SECTION 00 91 15

ADDENDUM NUMBER 6

- 1.01 DATE: APRIL 6, 2021**
- 1.02 PROJECT: WELCOME CENTER**
- 1.03 PROJECT NUMBER: DCM NO. 2020604**
- 1.04 OWNER: ALABAMA A&M UNIVERSITY**
- 1.05 ARCHITECT: NOLA | VAN PEURSEM ARCHITECTS, PC**

SHEET NUMBER
A-7.1
 OF

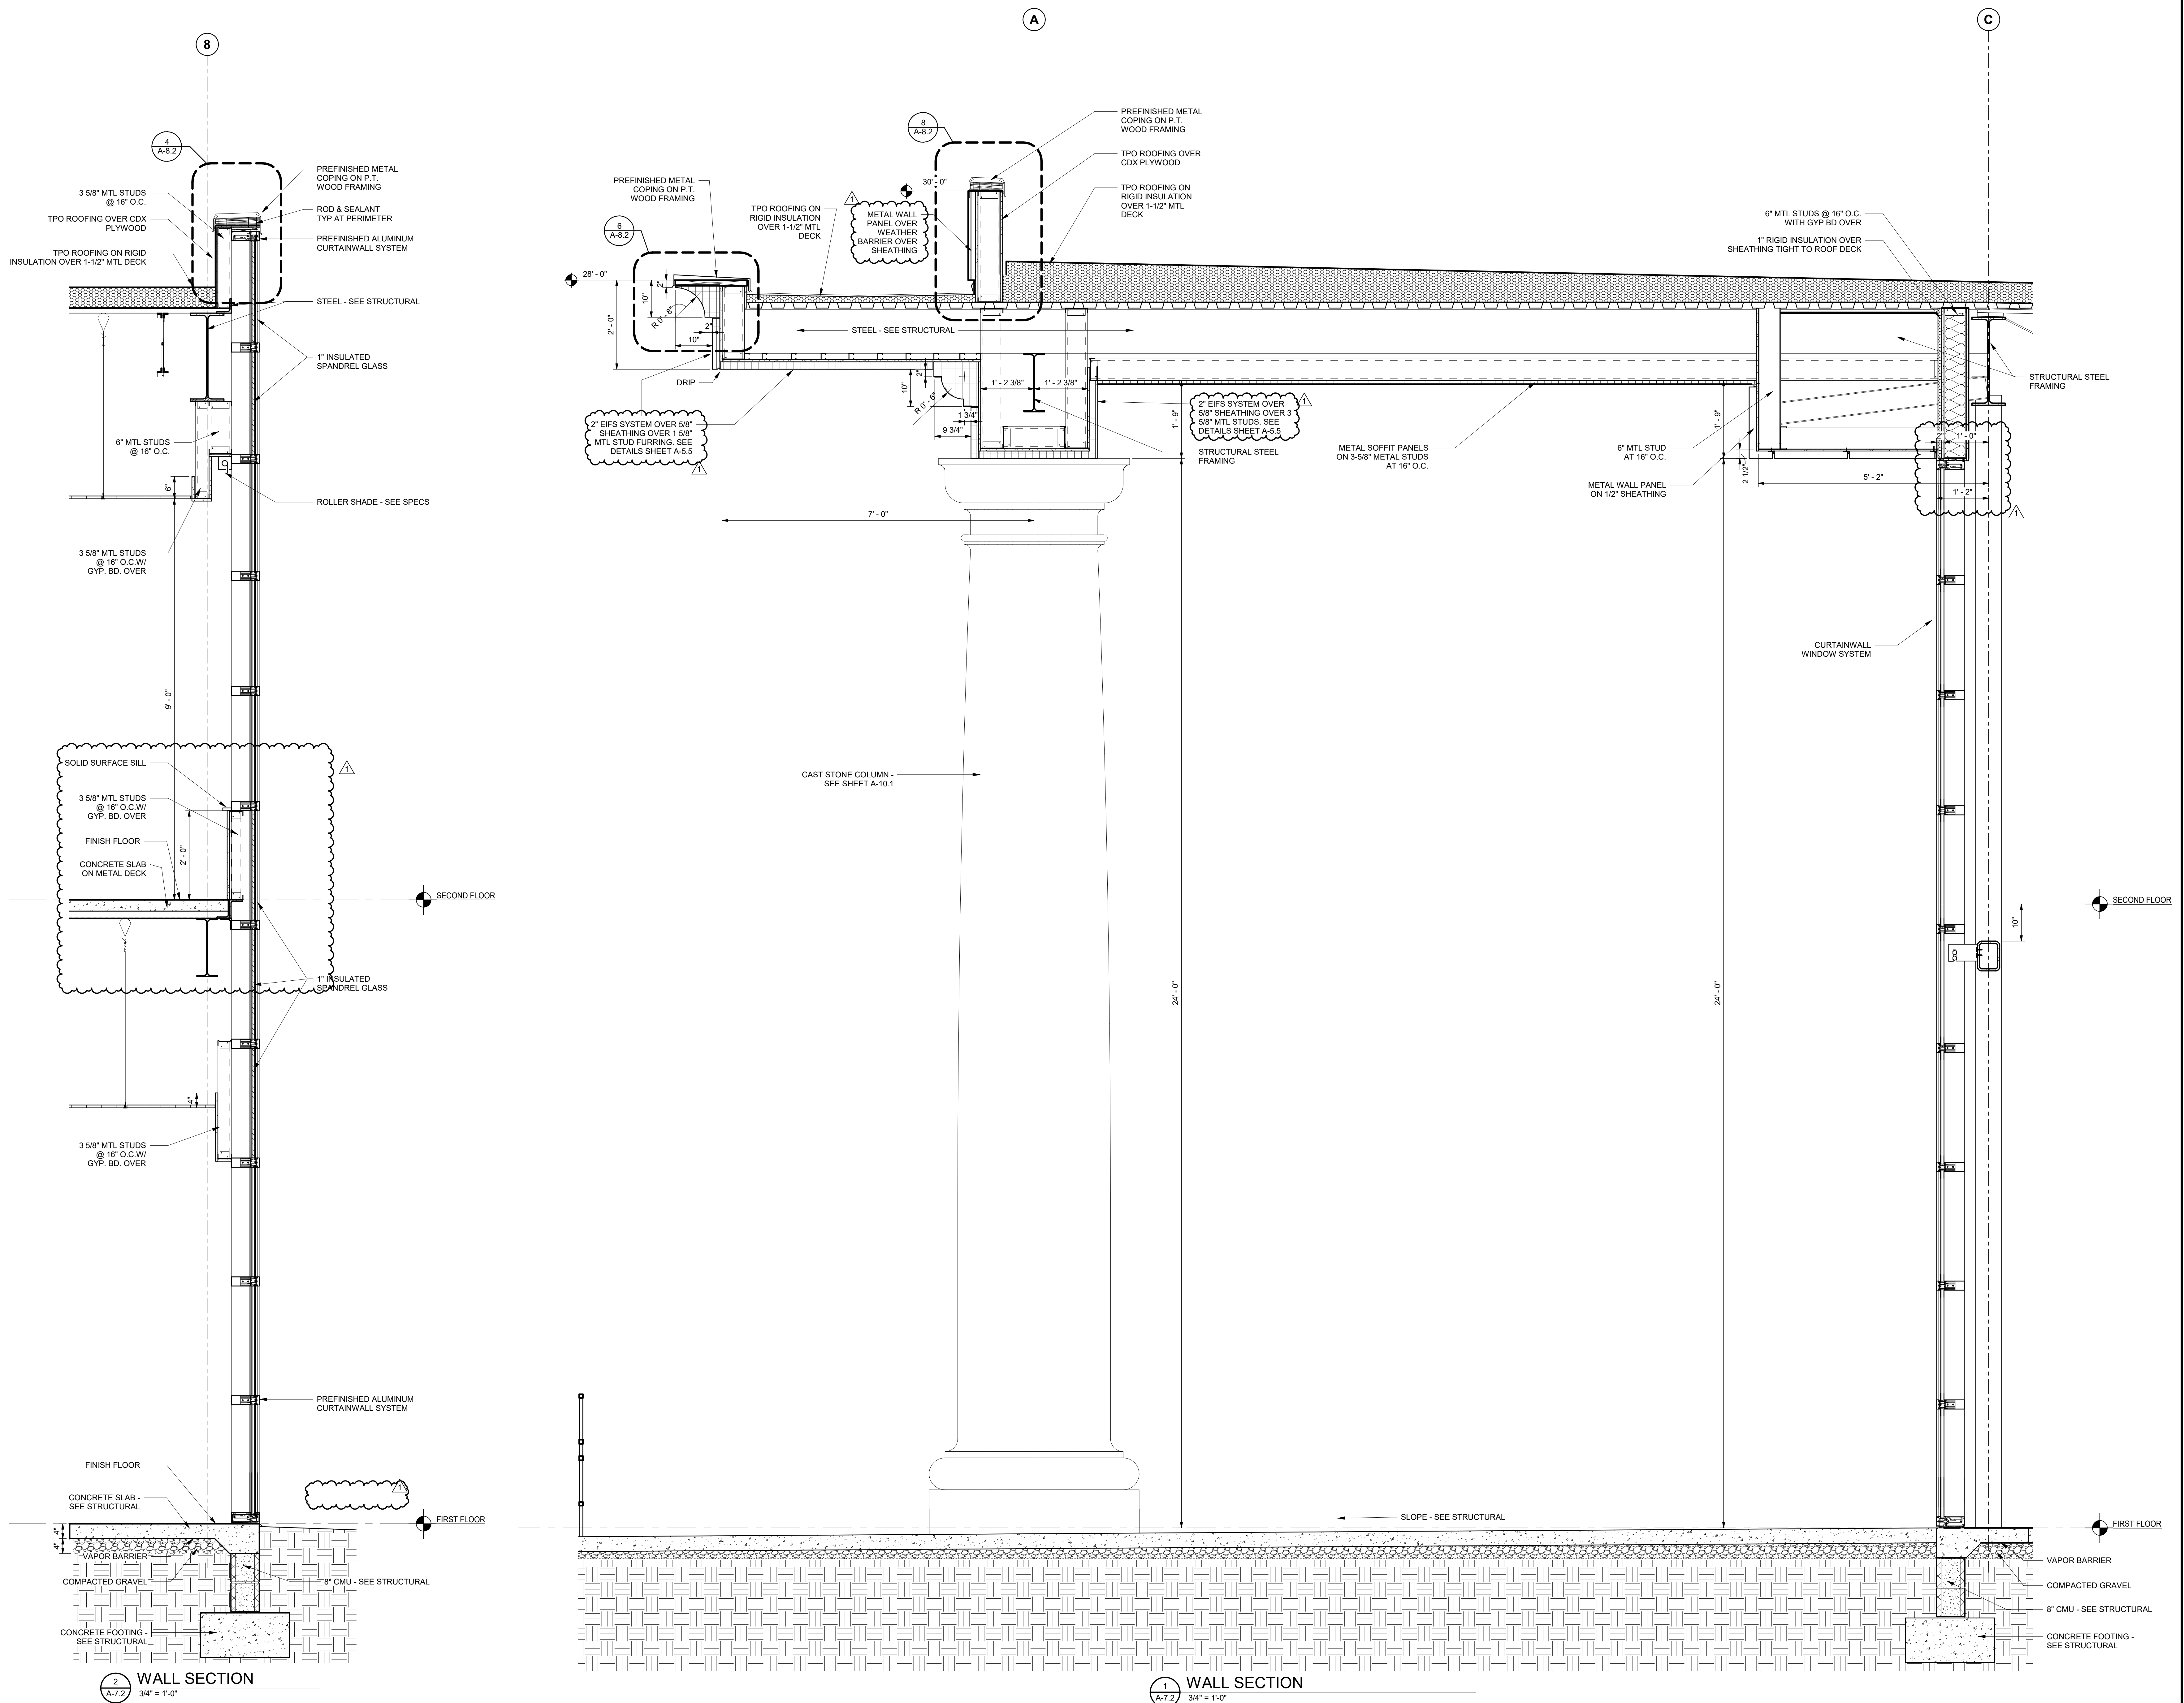
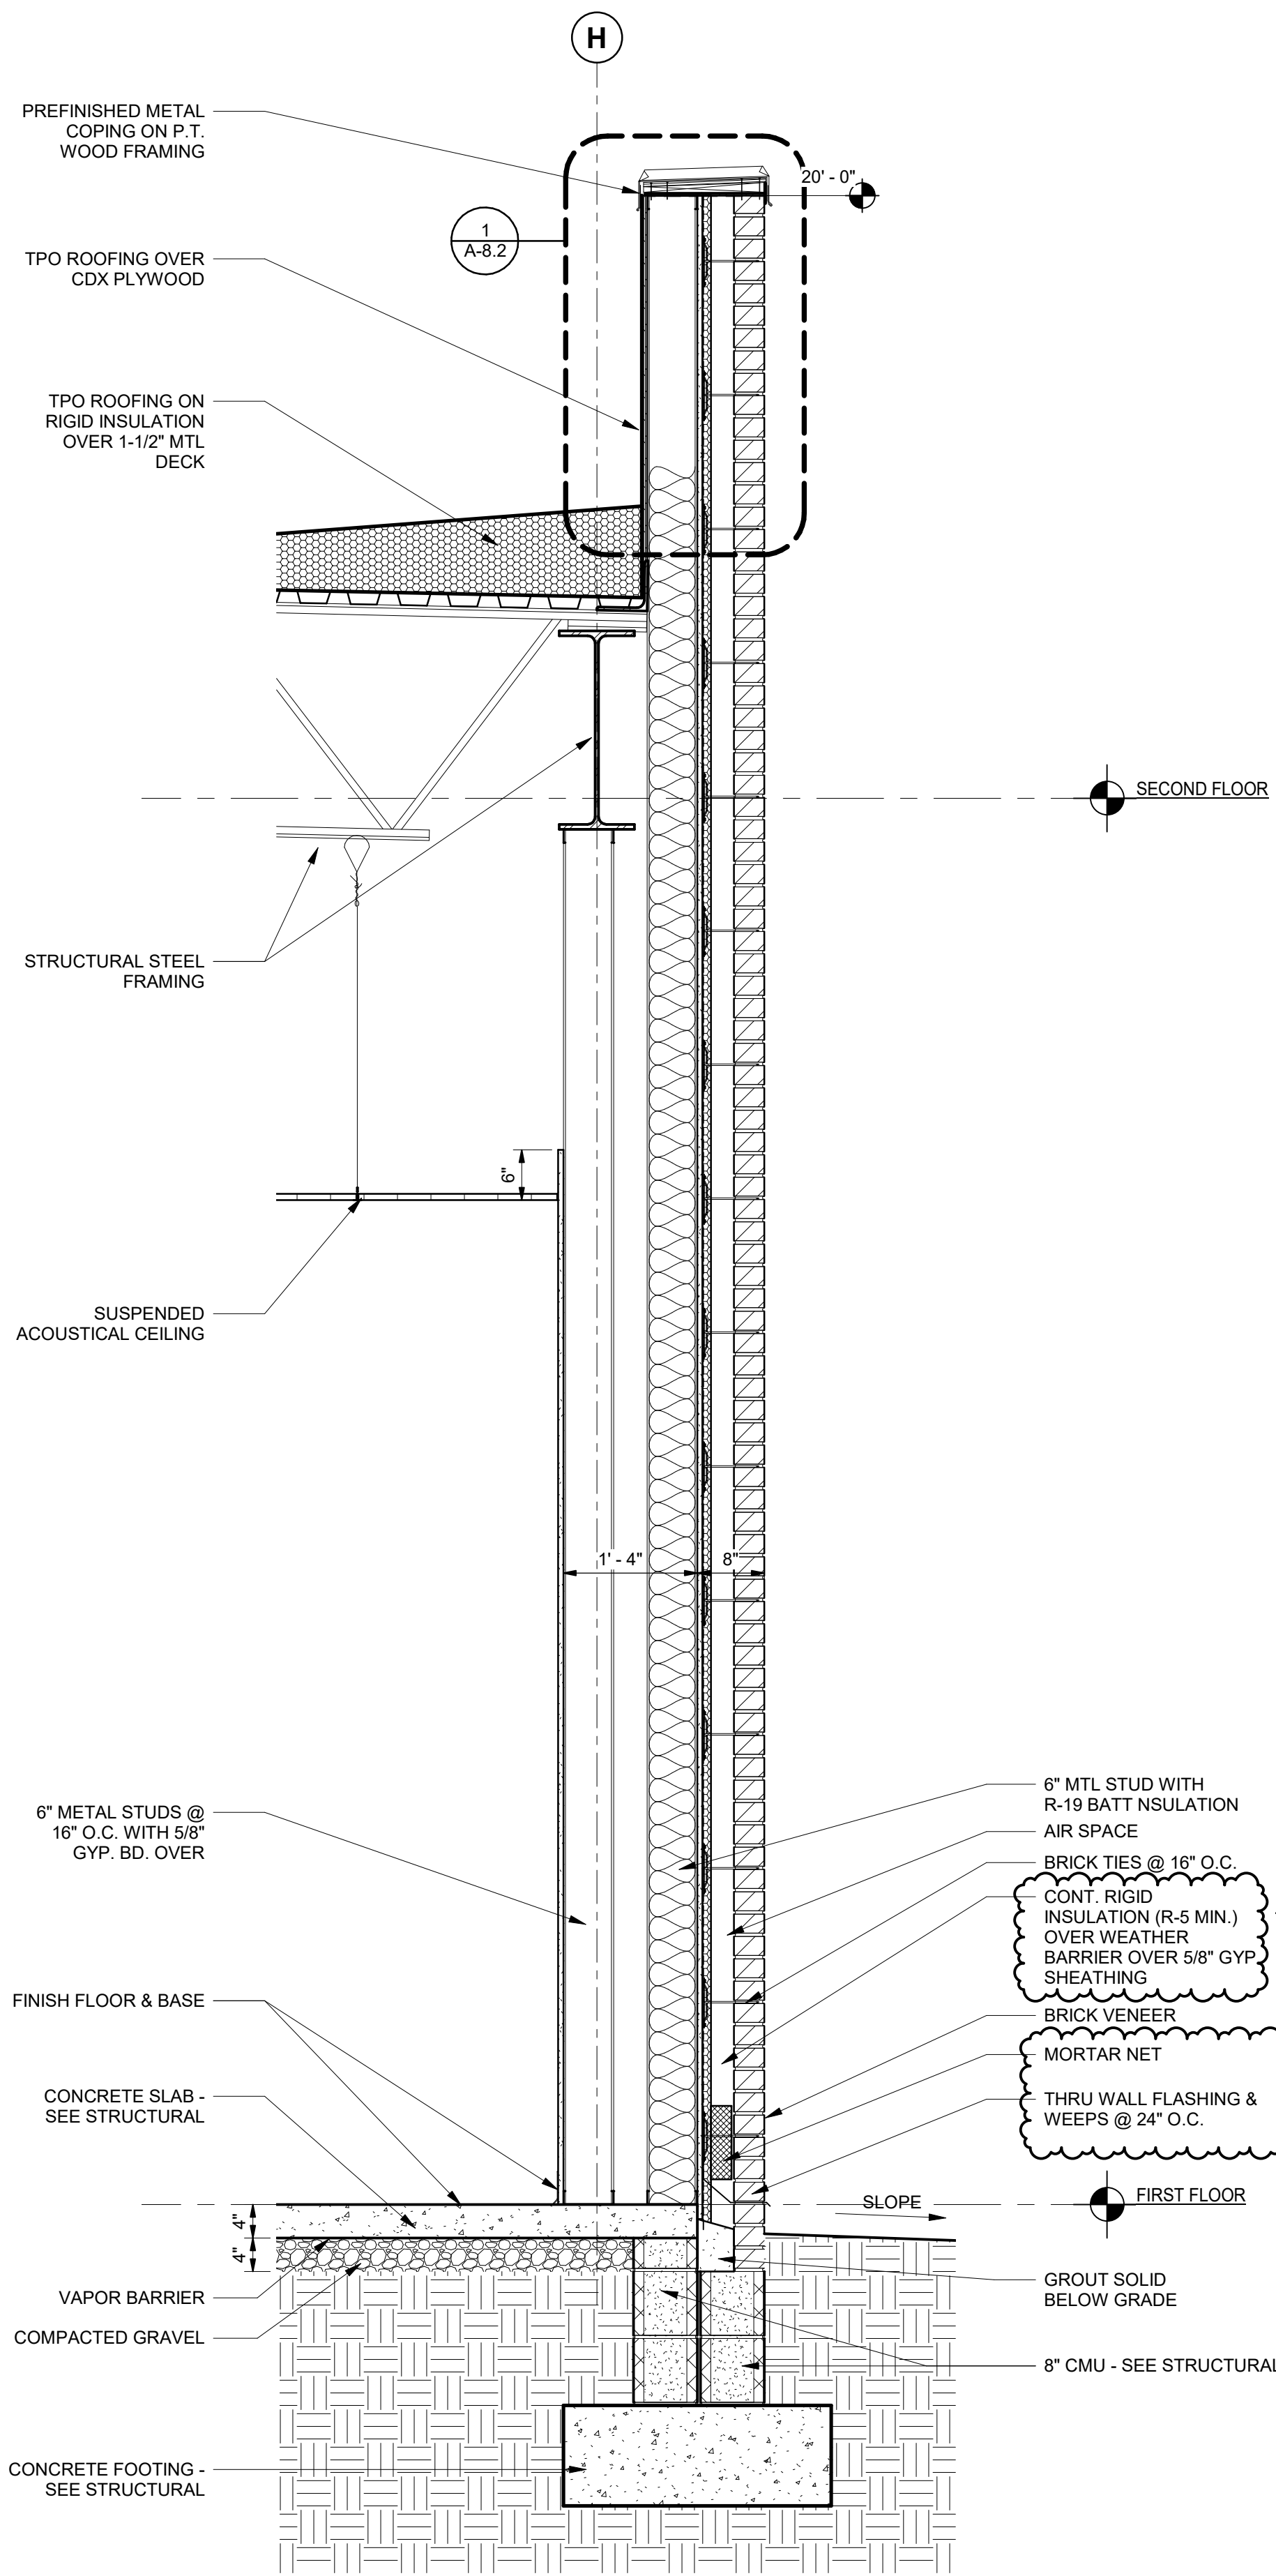
4.13 SHEET A-7.1 – WALL SECTIONS:

- A. Replace this sheet in its entirety. Revisions include the following:
1. Updated notes regarding weather barrier, mortar nets, and flashing.
 2. Updated exterior wall construction at second floor slab.
